Item Name: Crosstube Turning Detail

<b>DART AEROSPACE LTD</b>	<b>Work Order:</b> 81140
<b>Description:</b> Crosstube Assembly (205/212/412 High Fwd)	<b>Part Number:</b> D212-664-141
<b>Inspection Dwg:</b> D212-664-141 Rev: D	<b>Page 1 of 1</b>

DRAWING NO. D212-664-141	TITLE XTUBE ASSY (205/212/412 HI FWD)	REV. D	DART AEROSPACE LTD ENGINEERING ORDER		D.E.O. NO. D212-664-141-D-1	SHEET NO. SHEET 1 OF 2	SCALE NTS
DRAWN	CHECKED	MFG. APPR.	APPROVED	DE APPR.			
DATE 11.04.07	DATE 11.04.11	DATE 11.04.12	DATE 11/04/12	DATE 11.04.12

DRAWING NO. D212-664-141	TITLE CROSSTUBE ASS'Y (205 HI FWD)	REV. D	<b>DART AEROSPACE LTD ENGINEERING ORDER</b>	D.E.O. NO. D212-664-141-D-2	SHEET NO. SHEET 1 OF 1	SCALE NTS
DRAWN <i>UP</i>	CHECKED <i>AS</i>	MFG. APPR. <i>AS</i>	APPROVED <i>MD</i>	DE APPR. <i>MD</i>		
DATE 11.07.15	DATE 11.07.20	DATE 11.07.21	DATE 11/07/21	DATE 11.07.21

**D212-664-141/-141B  
ASSEMBLY DETAIL**

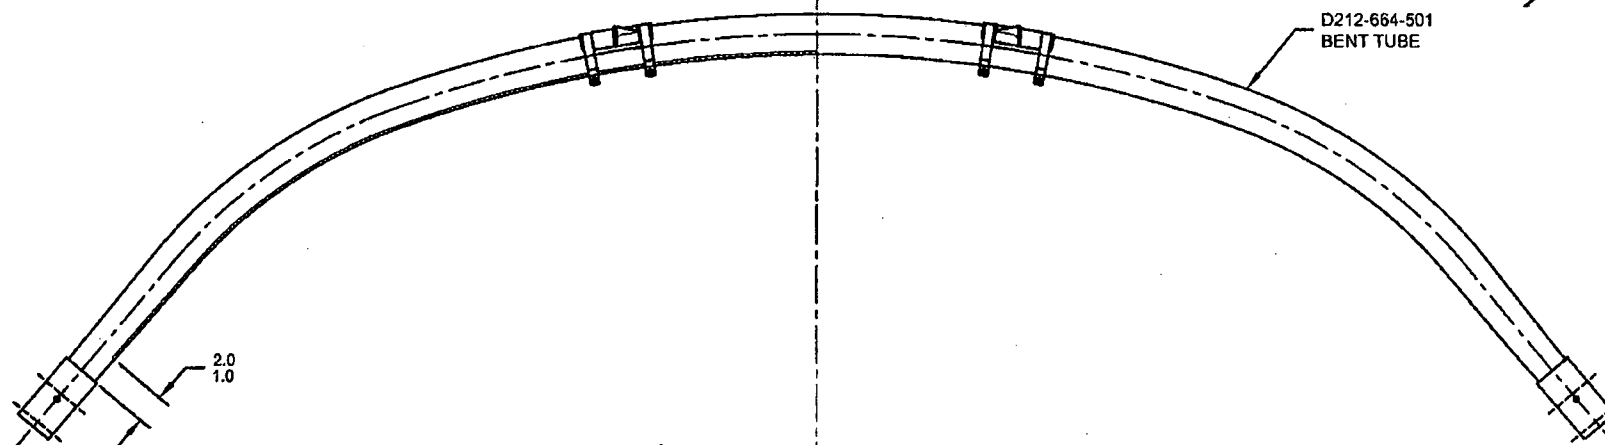
**PURPOSE:**  
ADD AN INSPECTION WINDOW TO UNDERSIDE OF CROSSTUBE.

NOTES 2 OF SHEET 1 IS AMENDED AS FOLLOWS:

MASK AREA PRIOR TO PAINTING,  
REMOVE MASKING AFTER PAINT  
AND APPLY CLEAR COAT

- 2) FINISH: CHEMICAL CONVERSION COAT PER DART QSI 005 4.1  
PRIME INSIDE AND OUTSIDE PER DART QSI 005 4.2  
MASK UNDERSIDE OF CROSSTUBE AS SHOWN (HATCHED AREA) AND  
PAINT OUTSIDE PER DART QSI 005 4.2  
REMOVE MASKING AND APPLY CLEAR COAT
